**UN Regulation No. 129 (Enhanced Child Restraint Systems)**

### **Proposal for draft Supplement 11 to the original version of UN Regulation No. 129 (Enhanced Child Restraint Systems)**

**Submitted by the expert from Spain\***

Figure 3  
Minimum distance for lateral impact

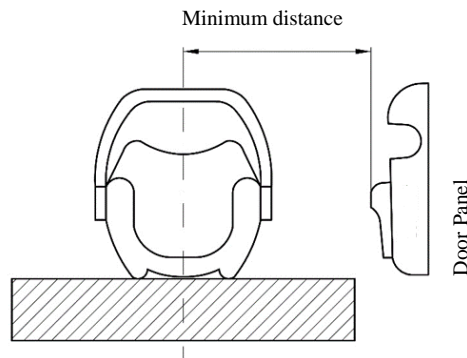
**For each test, the initial position of the side impact door panel relative to the bench shall be adjusted according to the minimum distance between the vehicle's door panel and the centre of the seating position as shown in Figure 3.**
